Subject: Duane Arnold Energy Center
Docket No: 50-331
Op. License No: DPR-49
Response to Request for Additional Information (RAI) to Technical
Specification Change Request TSCR-042 – Extended Power Uprate.
(TAC # MB0543)

Attachment: DAEC Responses to NRC Human Factors Branch Second Request for
Additional Information Regarding Proposed Amendment for Power
Uprate

6.2 Changes to Risk-important Operator Actions Sensitive to Power Uprate

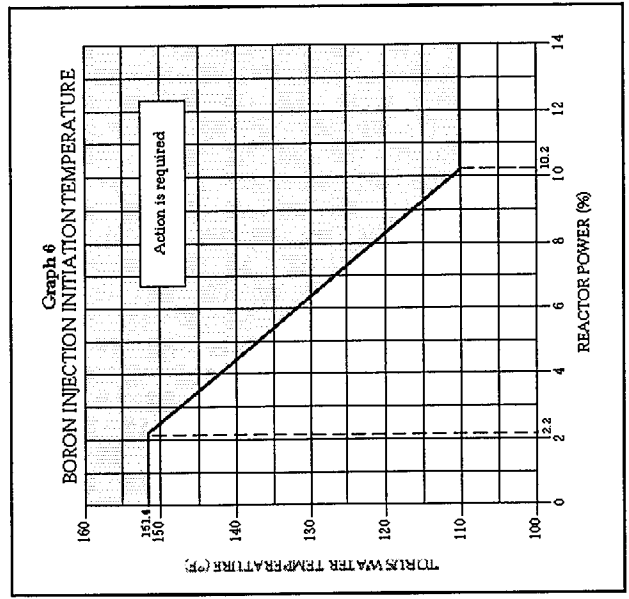
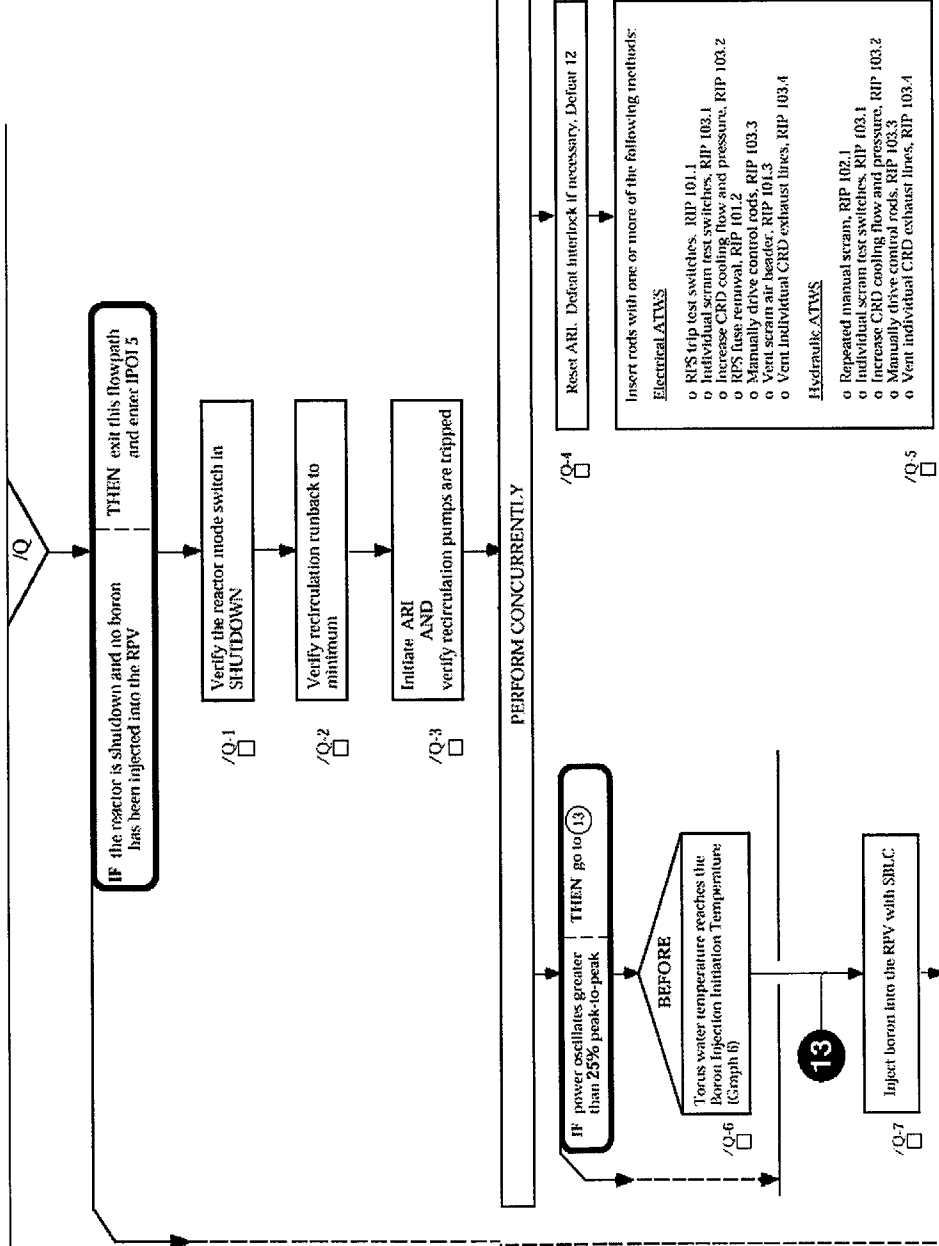
- (i) Provide additional detail regarding the actual Operator performance steps to diagnose the need for SLCS injection and the execution of that action, including a discussion of the controls on the use of the mode switch key used to initiate SLCS.

- (i) Attached is the relevant portion of the ATWS Emergency Operating Procedure (EOP) dealing with SLCS injection, i.e., Power Control (/Q). After entering this EOP, the Operator takes several immediate actions, such as placing the Mode Switch in “Shutdown,” ensuring the reactor recirculation pumps are at minimum pump speed, and initiating the Alternate Rod Insertion (ARI) and ATWS-Recirculation Pump Trip (ATWS-RPT) system, prior to reaching the steps dealing with SLCS injection. At this point in the scenario, after determining that a thermal-hydraulic instability does not exist, there is only one key parameter of interest, suppression pool (torus) temperature (See the BEFORE step (/Q-6) in the attached EOP.) Consequently, a Reactor Operator at the control panels, the Shift Supervisor and the Shift Manager are all monitoring the suppression pool temperature on the control room instrumentation. In addition, the suppression pool temperature is monitored on the Safety Parameter Display System (SPDS); in particular, the SPDS is automatically trending the temperature directly on the Boron Injection Initiation Temperature (BIIT) curve, the EOP criteria for SLCS injection. This display is monitored by both the Shift Technical Advisor (STA) and the Shift Manager, in addition to being plotted manually on the BIIT curve on the EOP chart. Therefore, it is highly unlikely for the suppression pool temperature to increase beyond the BIIT curve limit undetected by the Operators.

Given this recognition that SLCS injection is required, per the ATWS-EOP step (/Q-7) to “Inject boron into the RPV using SLCS,” execution of this task is very simple – only 3 steps. Using three-part communication between the Reactor Operator and the Shift Supervisor which reduces the potential for miscommunication, upon direction from the Shift Supervisor to initiate SLCS, the Reactor Operator 1) removes the key from the Reactor Mode Switch; 2) places it in the handle of the SLCS pump control switch and unlocks it; and then, 3) turns the SLCS pump control switch (a simple, two-position switch) from “Off” to the “PUMPS A and B Run” position. The two switches are located on the same control room panel and are within a couple of feet of each other. Hence, the Operator does not have to change physical location to perform this action.
